ECE/TRANS/WP.29/2009/18
17 December 2008

Proposal for Supplement 33 to the 03 series of amendments to Regulation No. 37
(Filament lamps of power driven vehicles and their trailers)

Submitted by the Working Party on Lighting and Light-Signalling (GRE) */

Sheet H10W/1

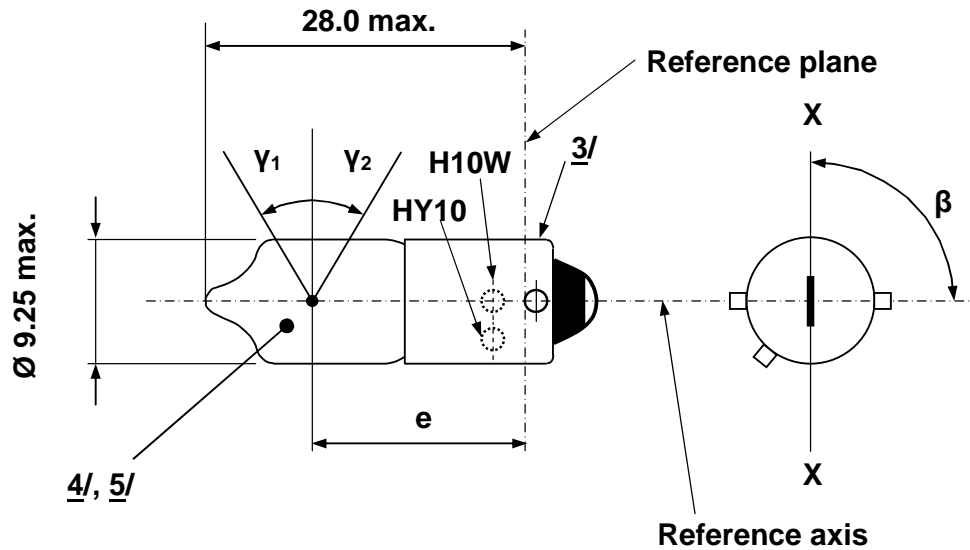
Insert new sheets H10W/1 to 2, between sheet H6W/1 and sheet H21W/1, to read (see next pages):

Dimensions in mm		Filament lamps of normal production			Standard filament lamp
		min.	nom.	max.	
e		14.25	15.0	15.75	15.0 ± 0.25
Lateral deviation <u>1/</u>				0.75	0.4 max
\square		82.5°	90°	97.5°	$90^\circ \pm 5^\circ$
γ_1, γ_2 <u>2/</u>		30°			30° min.
Cap: H10W: BAU9s HY10W: BAUZ9s		in accordance with IEC Publication 60061 (sheet 7004- [...]) in accordance with IEC Publication 60061 (sheet 7004- [...])			
ELECTRICAL AND PHOTOMETRIC CHARACTERISTICS					
Rated values	Volts	12			12
	Watts	10			10
Test voltage	Volts	13.5			13.5
Objective values	Watts	12 max.			12 max.
	Luminous flux	H10W	$200 \pm 12\%$		
		HY10W	$120 \pm 17\%$		
Reference luminous flux at approximately 13.5 V					White: 200 lm Amber: 120 lm

- 1/ Maximum lateral deviation of filament centre from two mutually perpendicular planes both containing the reference axis and one containing axis X-X.
- 2/ In the area between the outer legs of the angles γ_1 and γ_2 , the bulb shall have no optically distorting areas and the curvature of the bulb shall have a radius not less than 50 % of the actual bulb diameter.
- 3/ Over the entire length of the cap there shall be no projections or soldering exceeding the permissible maximum diameter of the cap.
- 4/ The light emitted from filament lamps of normal production shall be white for category H10W and amber for category HY10W.
- 5/ The light emitted from standard filament lamps shall be white for category H10W and amber or white for category HY10W. "
